# Staff Report

**Report To:** 102  
**Meeting Date:** July 2, 2024  
**Report Number:** PDS.24.002  
**Subject:** Recommendation Report – 24 Alfred Street REVISED  
**Prepared by:** David Riley, Principal, SGL Planning & Design Inc.

THAT Council receive Staff Report PDS.24.002, entitled “Recommendation Report – 24 Alfred Street Draft Plan of Subdivision and Zoning By-Law Amendment”;

**Figure 4. Excerpt from Site Grading Plan (Functional Servicing Report by Tatham Engineering)**

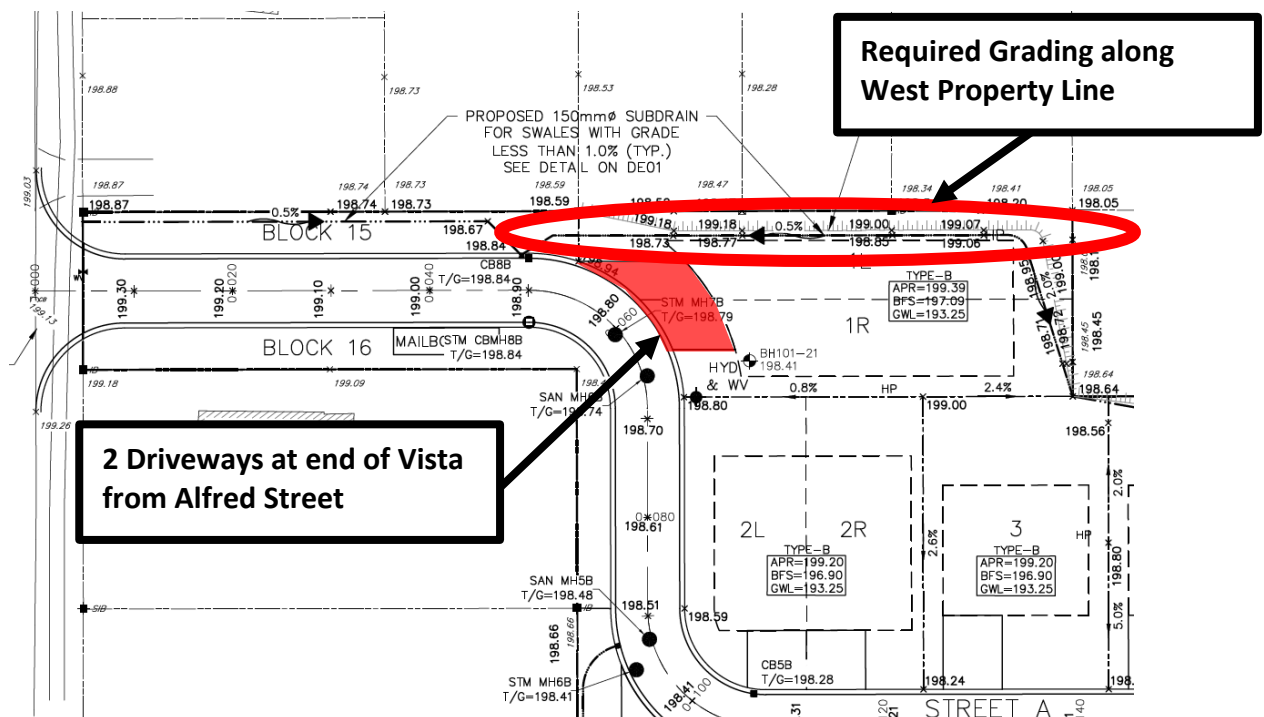
- However, Town Staff is concerned with the location of the pair of semi-detached dwellings that that can viewed from Alfred Street (Lot 1L and Lot 1R) for two primary reasons:

- The vista created from Alfred Street will be driveway and garage dominated due to the requirement for two driveways and separate garages to be provided (as shown on **Figure 4** below); and

- The proposed configuration of the lots is not appropriate given the proposed grading plan as presented in the Functional Servicing Report submitted in support of the proposed development (as shown on **Figure 4** below).

- As such, Town Staff has recommended to the applicant a revised plan of subdivision concept (see **Figure 5**), that sees this pair of lots for semi-detached dwellings (Lot 1L and Lot 1R) converted to a single lot for a single detached dwelling. This change would

address Town Staff's concerns by reducing the number of driveways visible from Alfred Street, increasing the amount of landscaping visible from Alfred Street, and addressing Town Staff's concern about the feasibility of locating a semi-detached dwelling on the lot given the required grading along the west property line. ***This is one of the reasons a deferral is being recommended, as Town Staff's position is that the proposed draft plan of subdivision needs to be revised to address this matter.*** The added benefit of changing Lot 1L and Lot 1R into one lot for a single detached dwelling is that there is an opportunity to provide for a greater side yard setback than would be afforded by the semi-detached dwelling, which will create a better and more compatible interface between the side lot line of this lot, and the rear lot lines of the adjacent lots on Elma Street.

Figure 5. Town Recommended Subdivision Concept

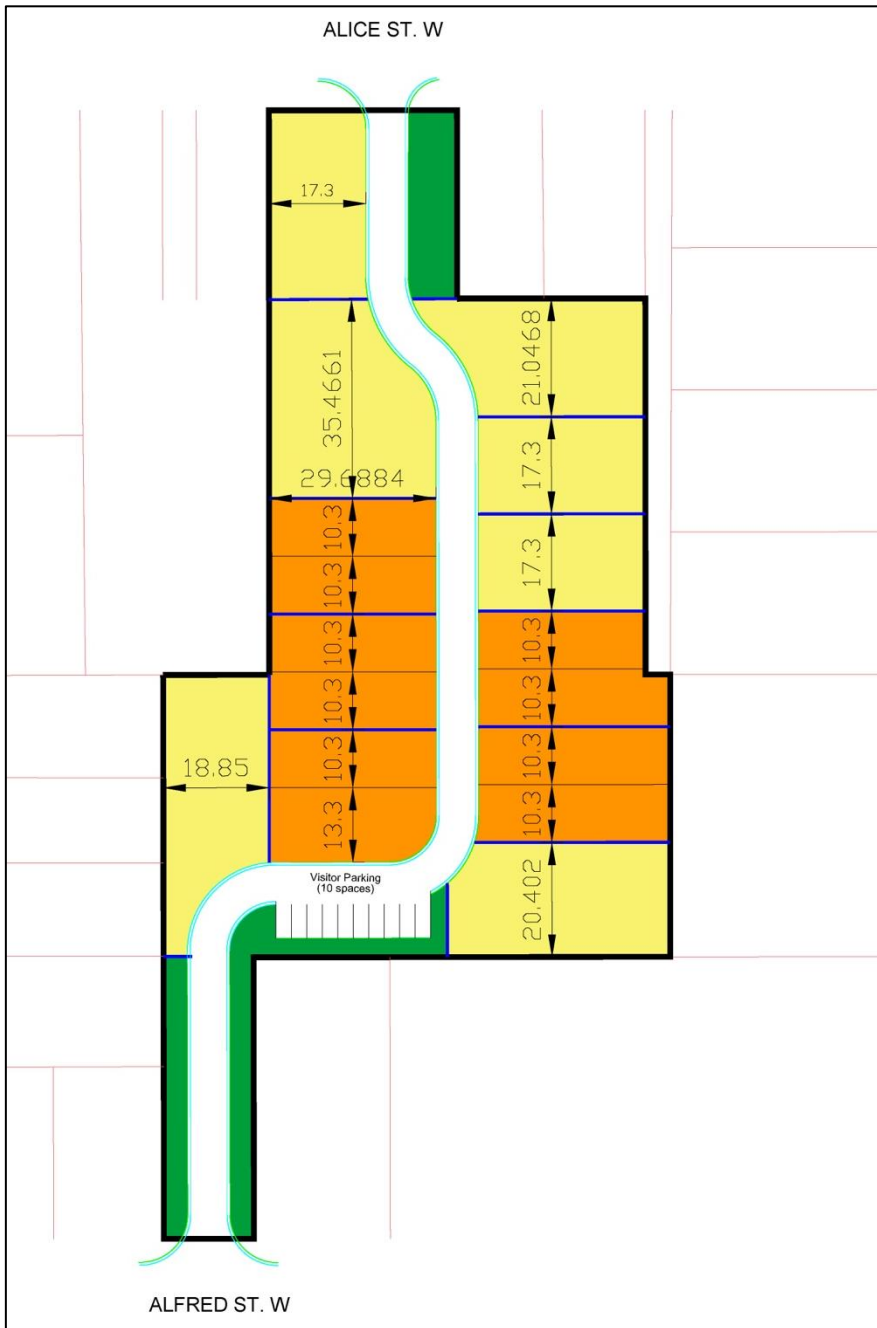
- Town Staff accept and agree generally with the design, configuration and proposed operation of the proposed private road as a one-way road from Alfred Street to Alice Street. However, Town Staff have concerns with the proposed road for two primary reasons:

- There is no guest/visitor parking proposed; and
  - There is no space for snow storage during the winter months.
- The concern with respect to the lack of guest/visitor parking relates to the proposed semi-detached dwellings. While the proposed single detached dwellings are on lots that are wide enough to accommodate a 6.0-metre wide driveway, which would accommodate cars parked side-by-side while still maintaining a large portion of the front yard as landscaping, the proposed semi-detached dwellings would have smaller 3.0-metre driveways, unable to accommodate as many vehicles as driveways for single detached dwellings. The benefit of providing for a guest/visitor parking area is that parking for guests of all residents of the proposed development, and particularly for those living in semi-detached dwellings, can be accommodated on the subject site, without relying on the need for guests/visitors to park on surrounding streets in the neighbourhood. Additionally, the provision of a guest/visitor parking area would also create extra space for snow storage during the winter months.

- As such, Town Staff has recommended a revised plan of subdivision concept to the applicant (see **Figure 5**) that sees the minor reconfiguration of the private road to provide for ten (10) guest/visitor parking spaces, as well as an area that could accommodate snow storage during the winter months. This change would address Town Staff's concerns with respect to the private road. ***This is one of the reasons a deferral is being recommended, as Town Staff's position is that the proposed draft plan of subdivision needs to be revised to address this matter.***

- Town Staff has suggested that the guest/visitor parking area could be located to the rear of the lots fronting onto Alfred Street. The added benefit of providing for guest/visitor parking and a snow storage area in this location is that these elements created a buffer that can be landscaped to create an appropriate transition and visual buffer between the proposed development and surrounding existing homes.
